**RE: BAT Plan Review  
15892 Meadow Walk  
Woodbine, MD**

This letter is in response to the BAT Plan for 15892 Meadow Walk (Daisy Hill Estates, Lot 13). Upon review of the plan, some items need to be added or changed on the plan. Please revise the plan to include the following:

Re: Site Plan for BAT Installation  
15892 Meadow Walk  
Woodbine, MD  
15-018

**ONSITE SEWAGE DISPOSAL SYSTEM DESIGN PLAN**  
 DAISY HILL ESTATES

LOCATION: **PER APPROVED SITE PLAN. SEWAGE DISPOSAL AREA AND BAT UNIT LOCATION MUST BE STAKED BY LICENSED SURVEYOR PRIOR TO PRE-CONSTRUCTION INSPECTION.**

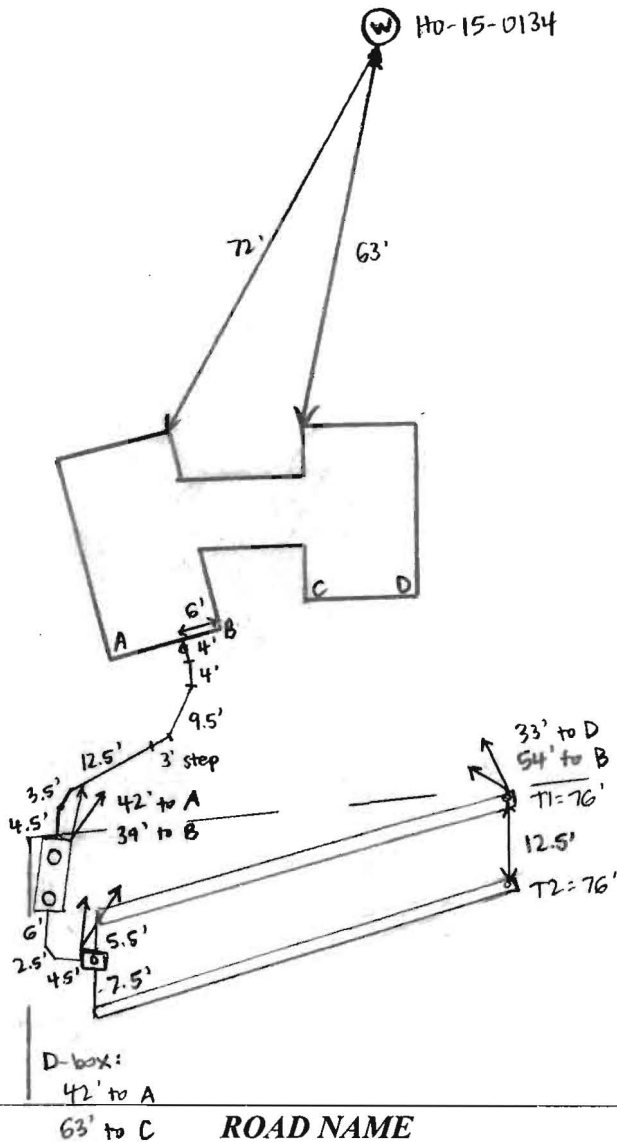
1/19/17 Met Fogle's on site for layout. No SDA stakes - 2<sup>nd</sup> trench and end of 1<sup>st</sup> staked. measured off house to confirm SDA corners. Shot contour - trenches staked to 75'. adjusted start of T1 to be on contour. Tank staked at 15' off house - moved down hill, farther from house, into SDA corner above T1. (SC)

1/20/17 Tank set. House connection made + pipe laid to tank. Line bedded with #57 stone. D-box set and connected to tank. (SC) 1/26/17 Fogle's installing trenches. T1 finished + left open at ends adding stone to T2. End of T2 only 6.5' - Fogle's deepened to 7'. They said they measured 7' up to last 10' of trench (no transit used). Levelled speed levelers in D-box. (SC)

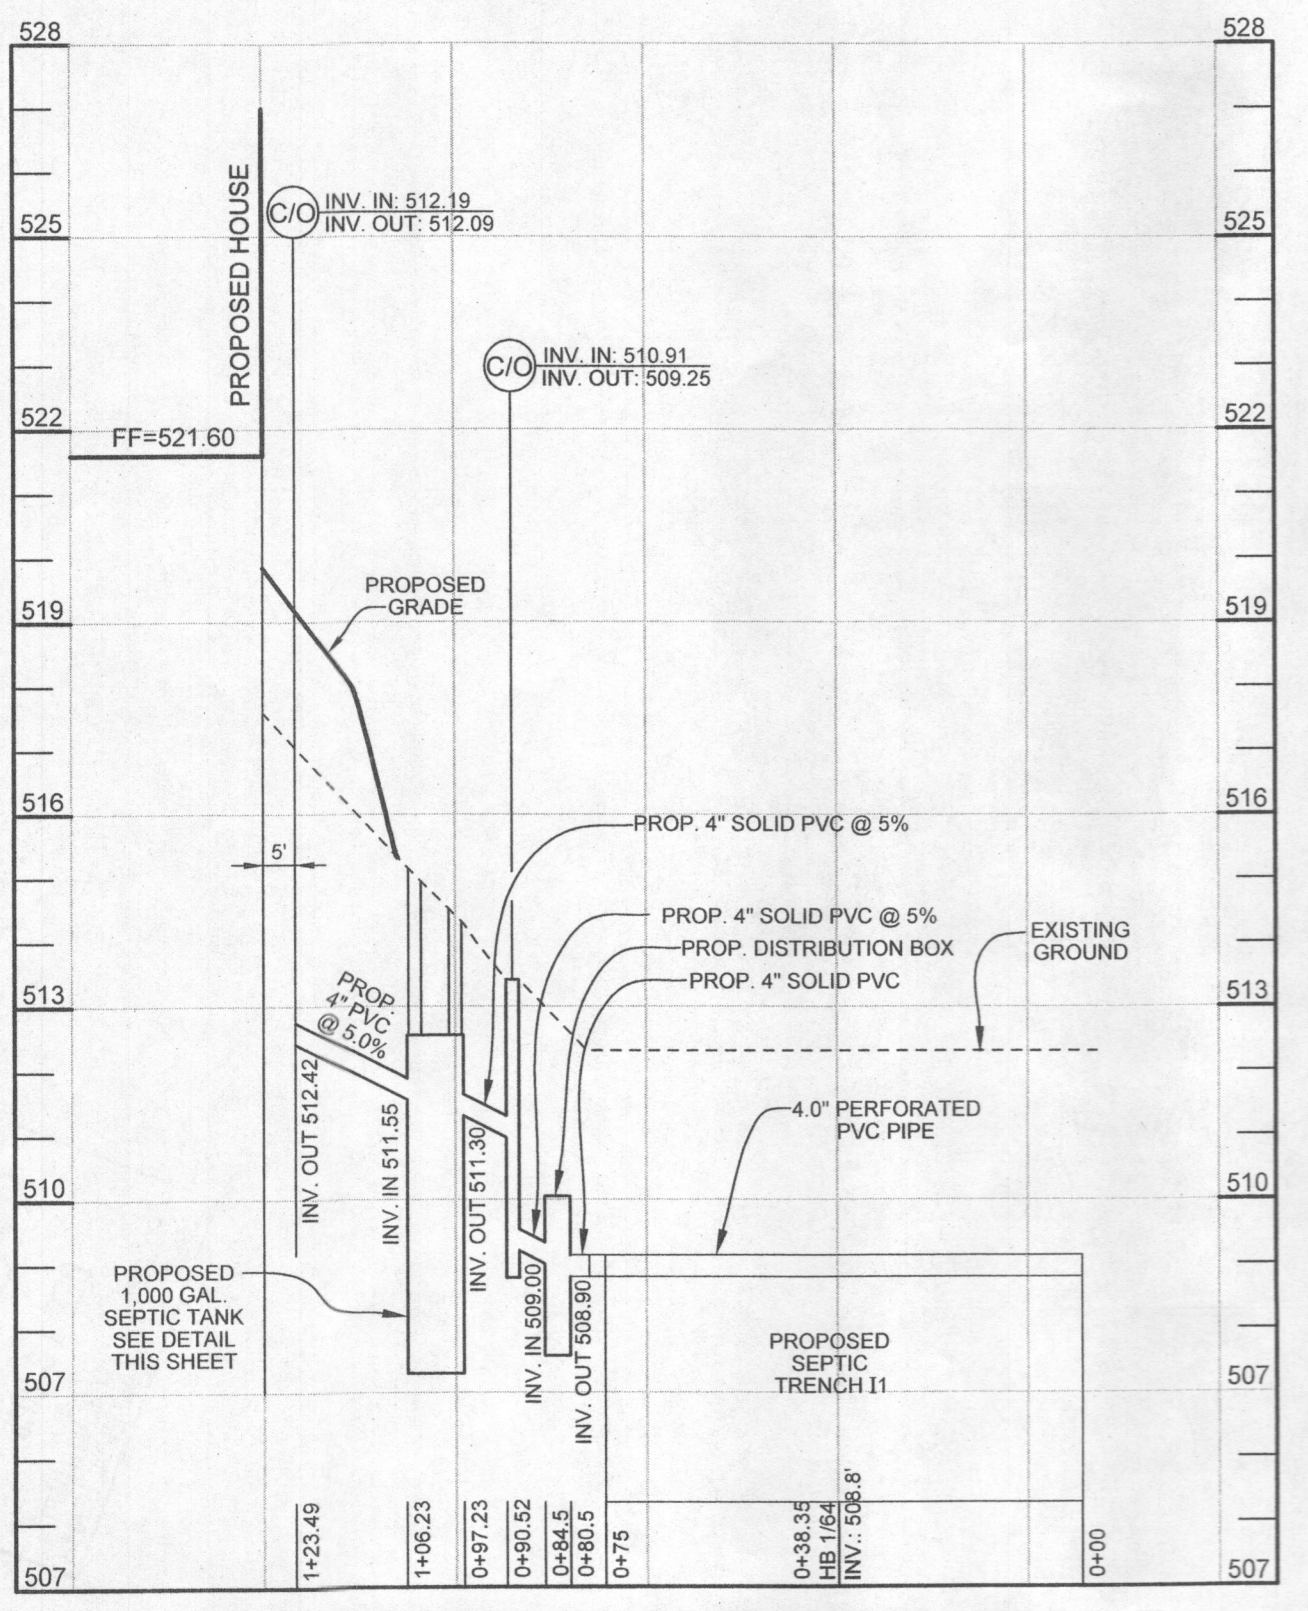
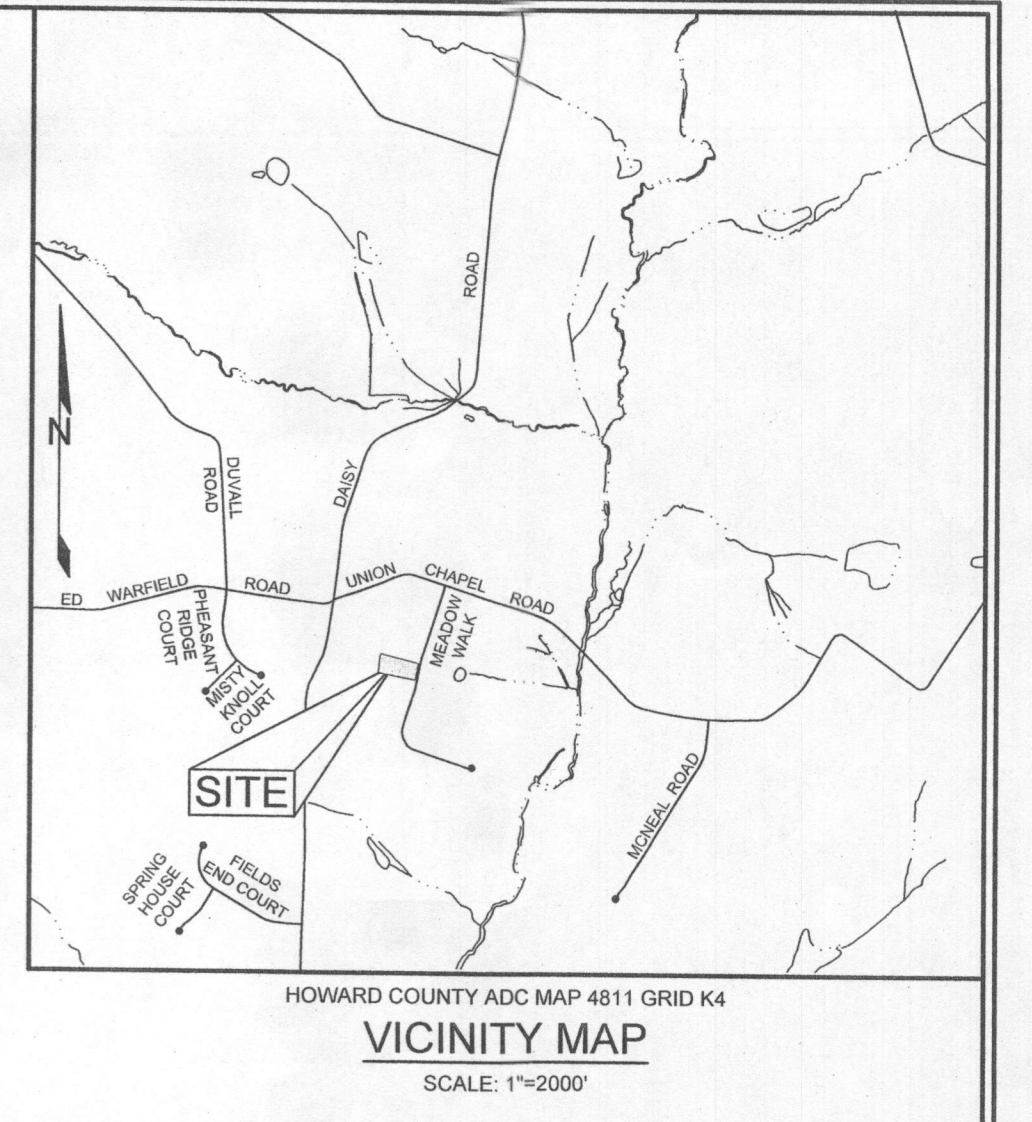
- 1.) Add actual well site to well box on plan and a note that well has been field located.
- 2.) Septic tank must be located 20 feet from house with basement.
- 3.) Rip-rap must be located 25 feet from septic easement and components.
- 4.) Replacement system calculation # 5 should be 150 FT (Not 174)

In response to your comments associated with the above referenced plan and dated January 29, 2016, please find this point-by-point response letter.

1. The well has been field located, and added to the plan.
2. The house does not have a basement. See architectural plans attached.
3. We are limited to have the rip-rap at the current location due to the Drainage and Utility Easement running on the south side of the property along the proposed road. Furthermore the swale that runs between the septic easement and the driveway, can't be placed closer to the driveway due to safety issues. Small size river-rocks will be used at the outfall of the roofleader, not the Class I type stone.
4. Replacement system calculation # 5 has been edited.
